**WOKINGHAM
BOROUGH COUNCIL**

Full Planning Approval Consultation

Application Number: 253110

Site Address: Brunningshams Farm, Heath Ride, Finchampstead, Wokingham, RG40 3QJ

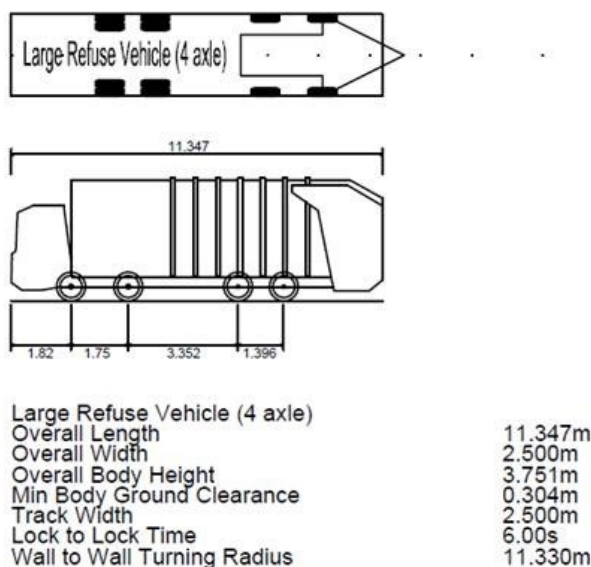
The TS states that a 11.3m long refuse vehicle has been tracked, however submitted drawing 25.52 – 001 shows a 11.2m long refuse vehicle. The applicant will need to provide the swept path for refuse vehicles entering and leaving the site in forward gear with the following standards:

In several places in drawing 25.52 – 001 it suggests that the swept path analysis has been undertaken with the lock-to-lock time or minimum vehicle speeds reduced from the default settings. When retracking with the correct vehicle, default settings should be retained.

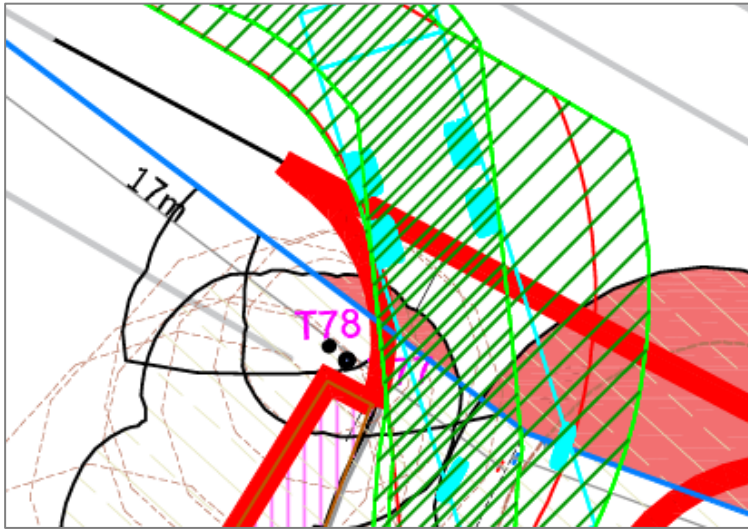
The swept path analysis of the vehicle entering the site access shows the vehicle overrunning the edge of the access and the hedge proposed, which is to be avoided. This has been shown below:

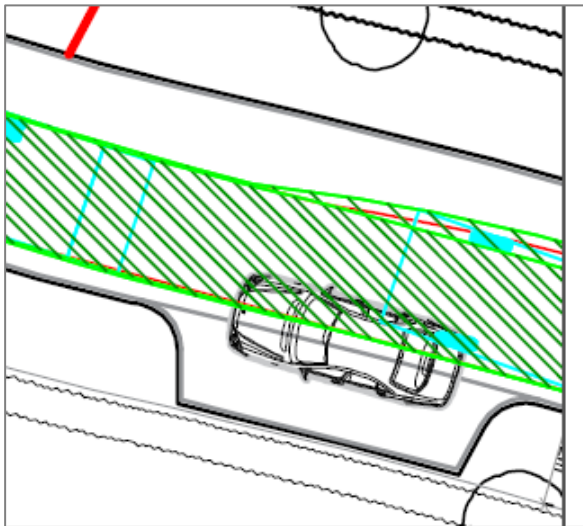
Drawing 25.52 – 001 also shows the refuse vehicle overrunning vehicles parked in the visitor parking bays along the internal access. This has been shown below. It is appreciated that refuse will only access the site infrequently, however visitors could still be parked here during these times. As mentioned above in 'Parking', adjusting the parallel bays to the correct dimensions may assist with this issue:
